SECTION 8.00-9.00 Planning Pre-App’s DM/23/1480 & DM/25/0133

Responses to and Comparables with Current Full Planning/Listed Building Consent Applications

8.00 Pre App DM/23/1480 and Current Proposal Responses & Comparables

8.01 Proposed Ground Floor Extension (A1) & Library Windows (A2)

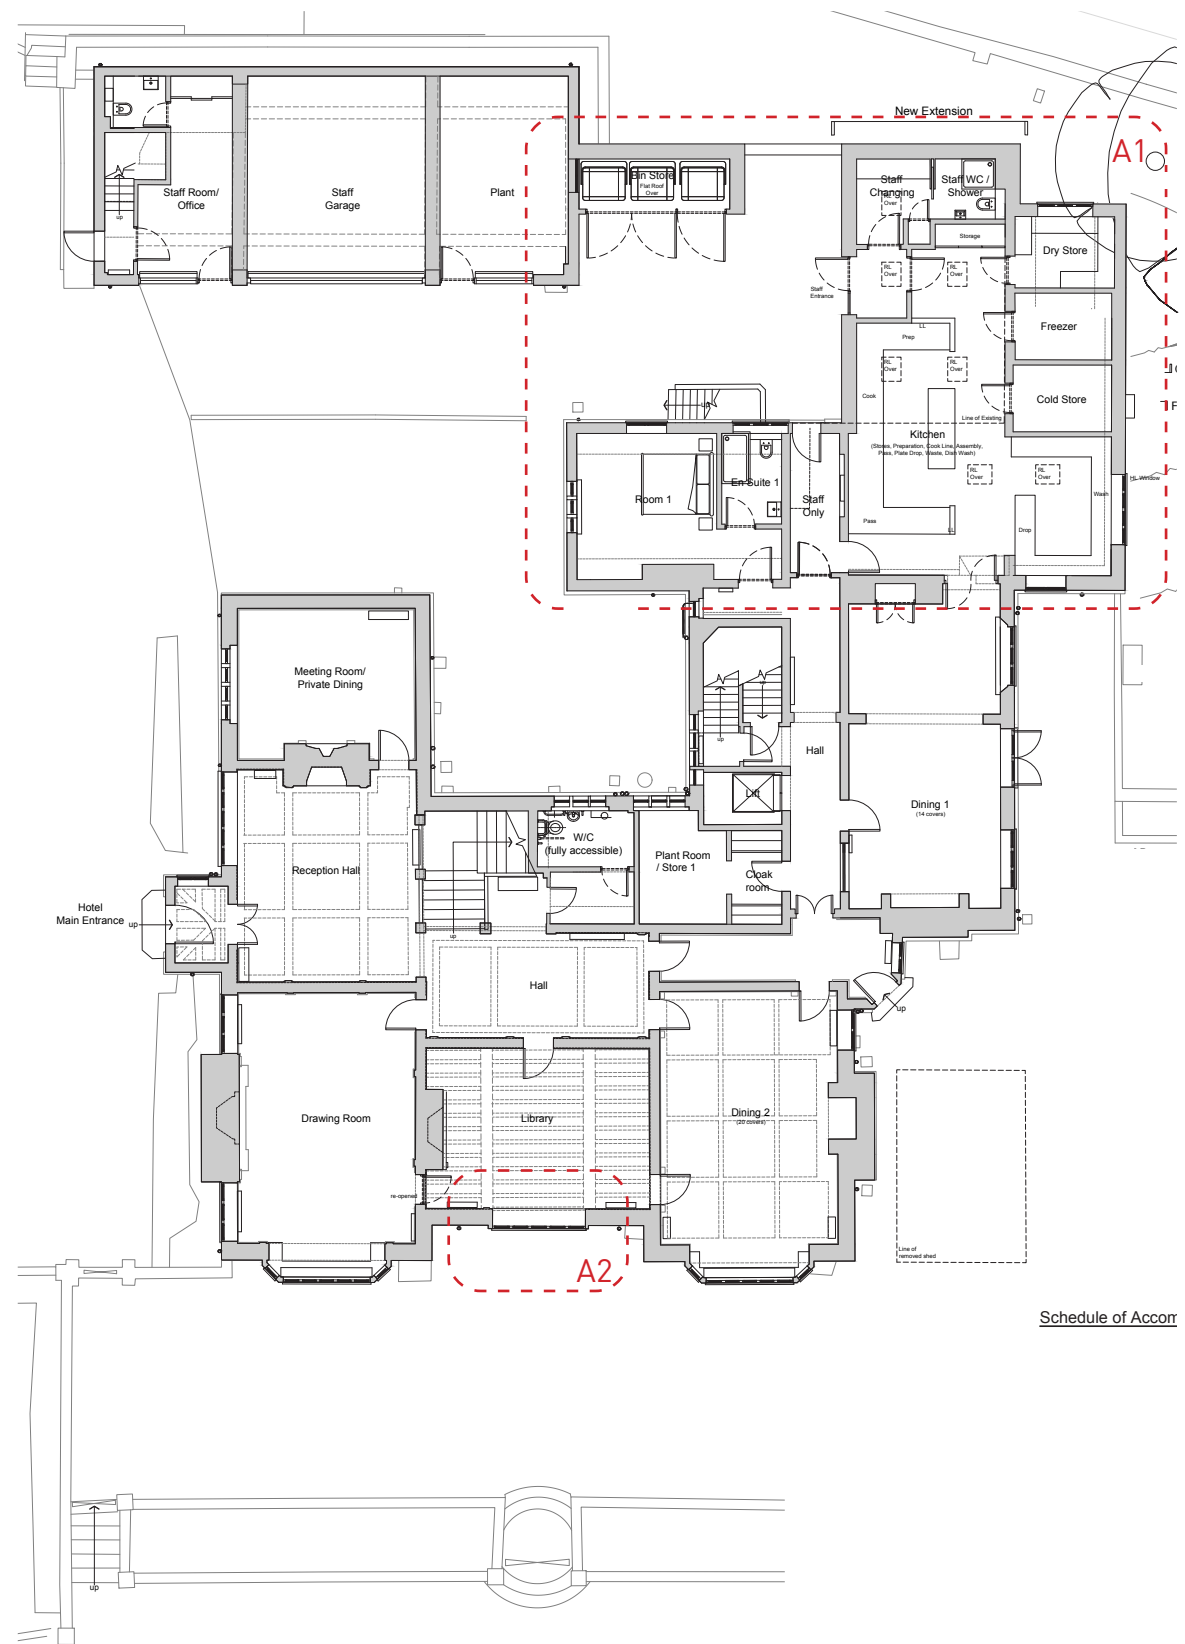
A1
“The proposed extension to the ground floor of the building is within the courtyard area to the north east of the building. This area is flanked to south and east by what appears to be the original service area/wing of the house, which while not as architecturally grand or imposing as the main part of the building containing the family rooms, is nonetheless of character and interest retaining original features such as leaded windows and doors onto the courtyard. The yard itself, with its herringbone brick pavers, is also an attractive feature of the setting of the house. Although towards the rear of the building, the yard area is visible in closer views from the main entrance drive to the house, and forms part of the context within which the main entrance façade is appreciated as one approaches the house along this drive. For these reasons I would question whether this is an appropriate position for an extension. In my opinion, a kitchen extension might be better positioned to the opposite side of the existing service wing (currently containing a gym), which although it would be visible from the terrace to the south east of the house, could if appropriately set back in relation to the main building (as the existing wing is), be appropriately subservient in views of the house from the terrace and gardens, and would allow the character of the courtyard facing elevation, which is in fact probably the more significant in terms of the context in which the house is appreciated, to remain largely intact, as well as the courtyard itself. In conjunction with this I would not object to a more modest extension to the northern end of the existing kitchen wing linking across to the modern garage building, providing this preserved the key features of the wing, and the character of the courtyard space.”

A2
“During our site visit we noted that the existing windows to the library are original, and the original fabric beneath them both internally (wood panelling, part of the designed decoration of the room) and externally (a stone plinth). The existing window is also part of the designed composition of the elevation. For these reasons I consider that the proposal to remove the fabric below the window sill, and replace the existing windows with French doors, is contentious, and will detract from the special interest of the listed building. This aspect of the proposal should be omitted from the formal scheme.”

A1
Whilst the comments of the LPA re. the pre-app proposal for the repositioning of the extension to the East of the listed building (in close proximity to the new spa and pool building) are acknowledged, there is a clear rationale for the positioning of the new extension to rear (North East) of the main building as cited opposite. However, mindful of the comments made, the overall size of the proposal has been reduced by c25Msq (c. 40%) in order to limit any perceived impact on the listed building.

A2
The comments of the LPA re. the pre-app proposal to remove the bay window and fabric below the window sill and replace with French doors are acknowledged and have been omitted from the current scheme. This area will therefore remain as existing.

8.02 Proposed First Floor Bedroom 4 & 5 (B1)

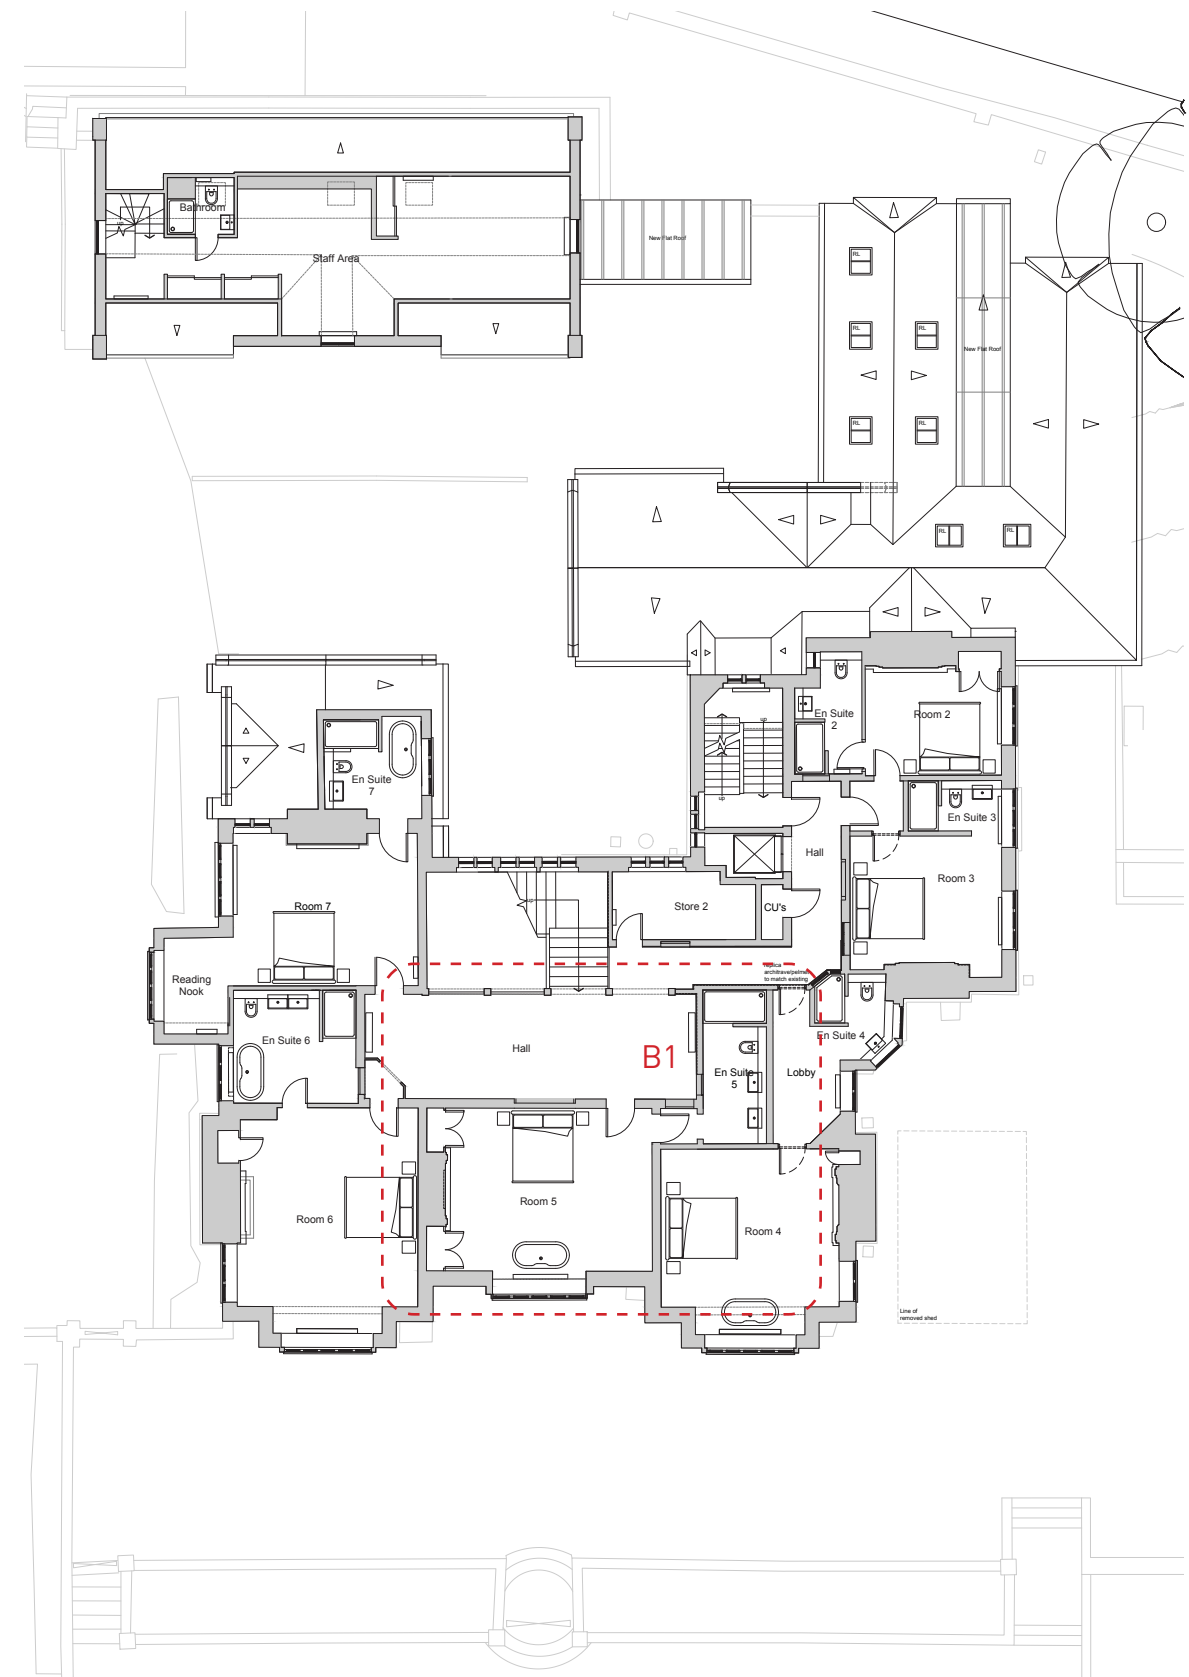
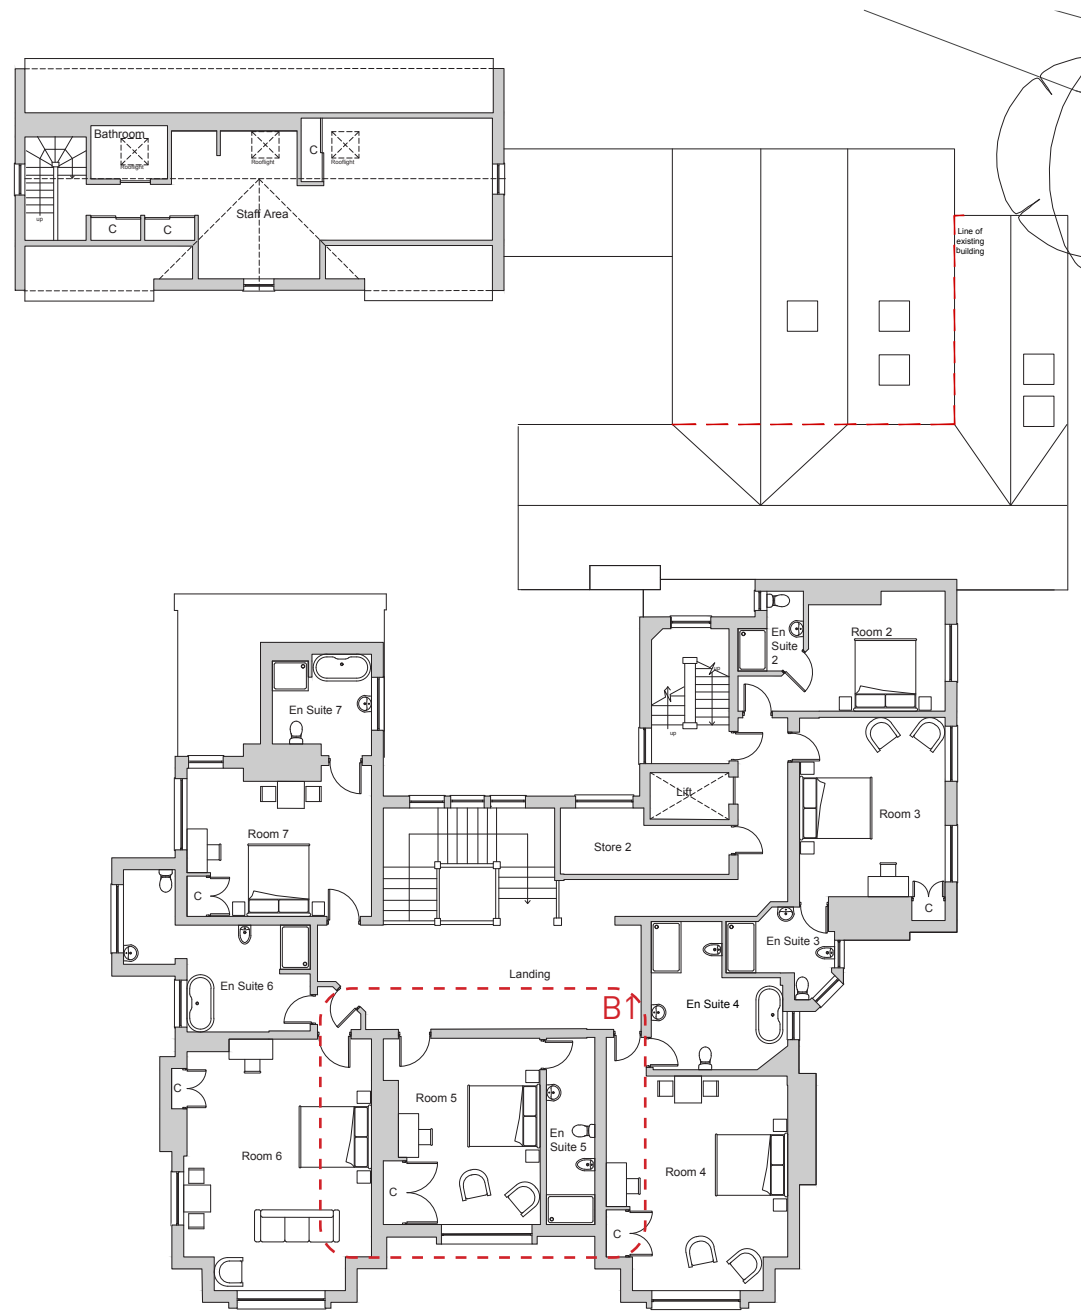
B1
"At first floor, the alterations to the existing floor plan are in general relatively minor in their impact, and are not considered contentious subject to detail in light of the existing permission. This is with the exception of the proposed works to bedroom 5, which involve bisecting the room by the insertion of an ensuite. This room is one of the principle family bedrooms, and the adverse impact on its original proportions which would result from the proposed work would in my opinion unacceptably impact on its character. This aspect of the proposal should be reconsidered- potentially the room, which is already linked with the adjacent master bedroom, could be incorporated into a suite with that room?"

B1
The comments of the LPA re. the pre-app proposal to insert an en-suite shower room into principal room 5 and bisect the space have been addressed with re-design to suit.

The current proposal maintains room 5 as existing, retaining its original features, cornicing, skirtings etc insitu including its entrance door from the landing (previously repositioned). The adjacent dressing room and ensuite to existing bedroom 4 is adapted to form a lobby, accessed from a new entrance door within the panelling of the hallway to match all other doorways on the landing area by replicating panelling, architrave, over door frieze and door / ironmongery to match existing complete. The new en suite is positioned off of the lobby (in the position of the existing en suite), modified to suit new layout to bedroom 4. The remaining part of the original dressing room is proposed as bedroom 5's ensuite.

8.03 Proposed Reading Nook (C1) & Second Floor Bedroom 13 (C2)

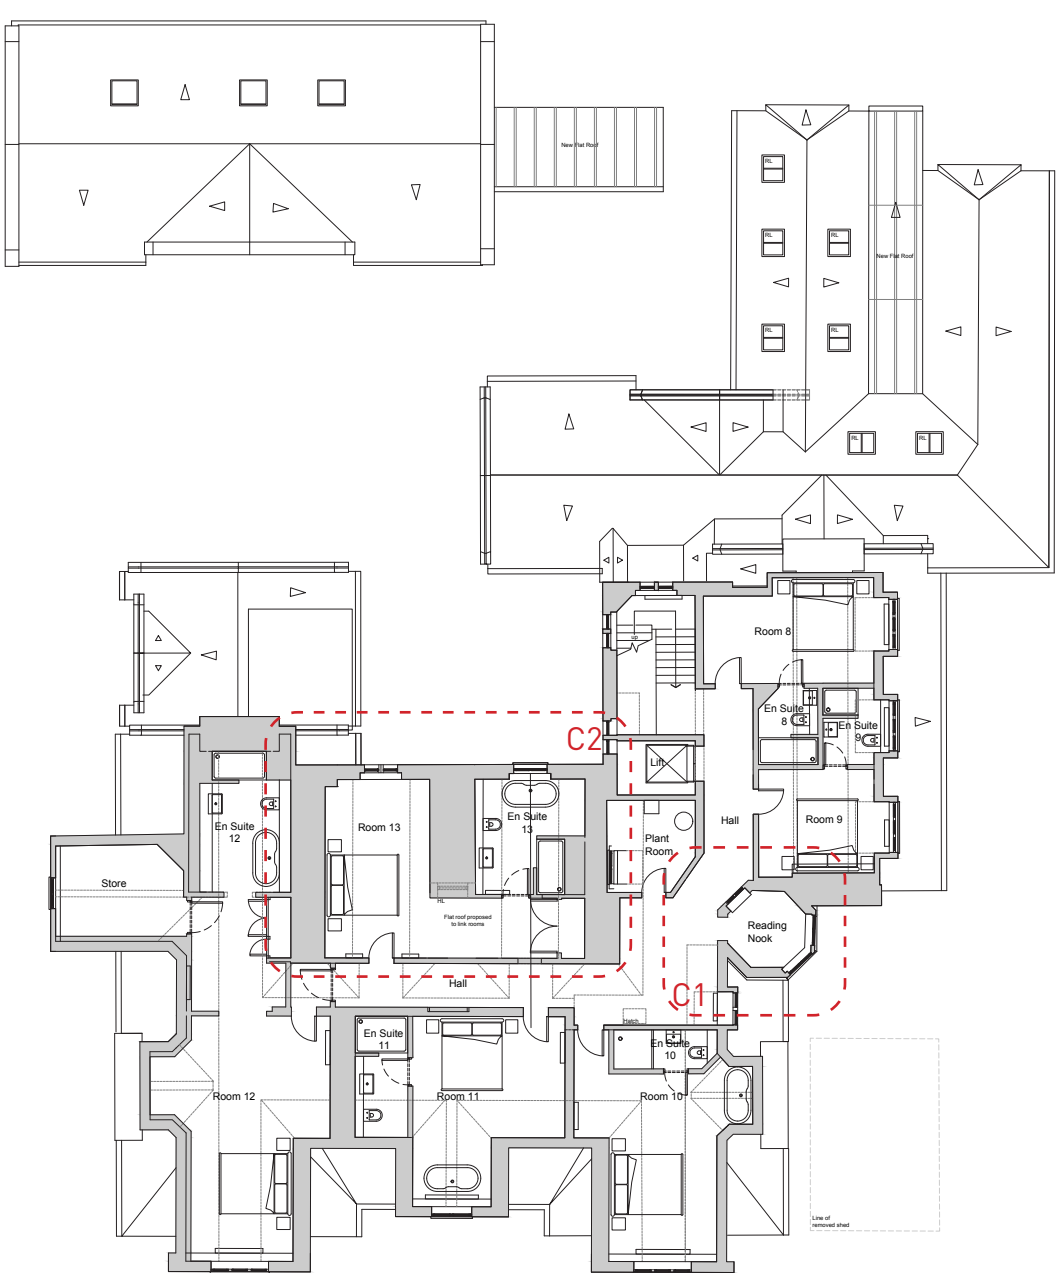
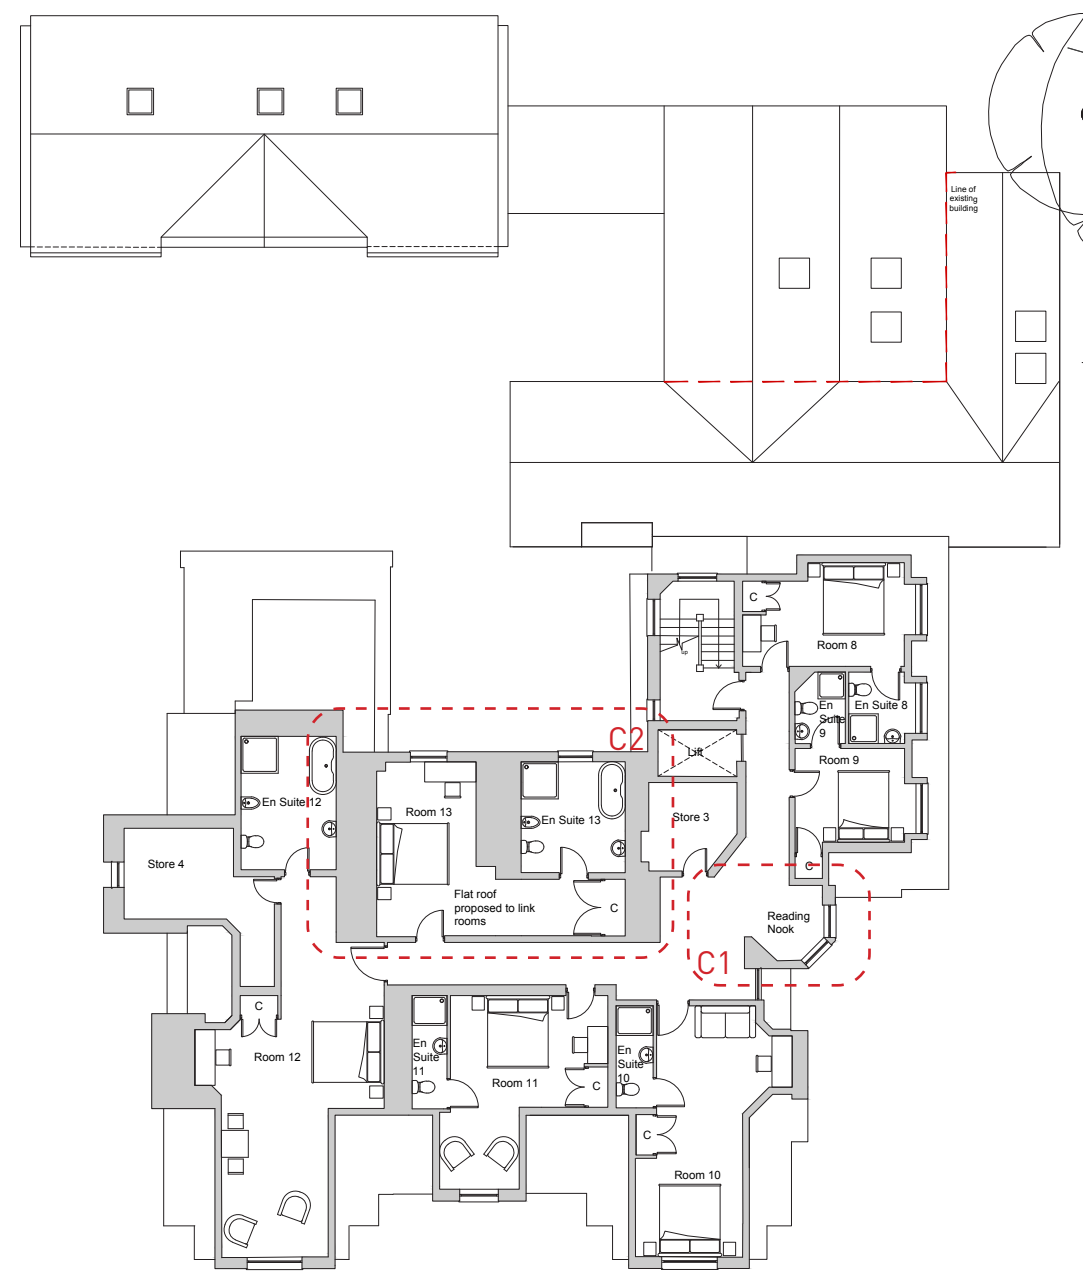
C1
“The proposal also shows the removal of wall enclosing the proposed ‘reading nook’- this would result in an unacceptable loss of historic plan form and fabric and I would suggest should be omitted from the scheme.”

C2
“At second floor, the majority of works relate to the insertion of ensembles to the existing attic bedrooms. Although this will have some impact on their proportions, given the secondary importance of these spaces this aspect of the proposal is on balance considered acceptable. It is also proposed to alter the roof form above the existing kitchen and adjacent bathroom/ walk through cupboard space to create an area of flat roof which allows the formation of a link between the spaces, to provide an additional ensuite bathroom. Further detail including proposed sections, elevations and a roof plan would be needed for fully informed comment, however in principle this may be acceptable, provided that there is no adverse impact on the external appearance of the building, and that as discussed on site, the internal character of the adjacent corridor, with the angled intrusions revealing the shape of the original roof above, is preserved. The level of interest of the joinery within the walk through cupboard space should also be considered- it is proposed to partially remove this, which is work which should be assessed in an accompanying heritage statement, and if necessary amendments- such as the reuse of the joinery in question elsewhere in that room - considered.”

C1
The comments of the LPA re. the pre-app proposal to remove part of the wall enclosing the proposed reading nook are acknowledged and thus this area will remain as existing.

C2
The comments of the LPA re. the pre-app proposal for the removal of part wall (including cupboards) to form a link between kitchen and bathroom are acknowledged. Proposed sections and elevations are included within the planning application package which shows no adverse impact on the listed building. The new link will have a traditional lead rolled flat roof over and this will be considerably withdrawn towards the rear of the section of roof set back behind the primary rear double gables. The new roof will not be visible from courtyard area at the rear. The existing joinery is not believed to be of significant heritage value, and it is not proposed to reuse these within the new proposals in a specific location. However they may be re-purposed in storage areas if appropriate.
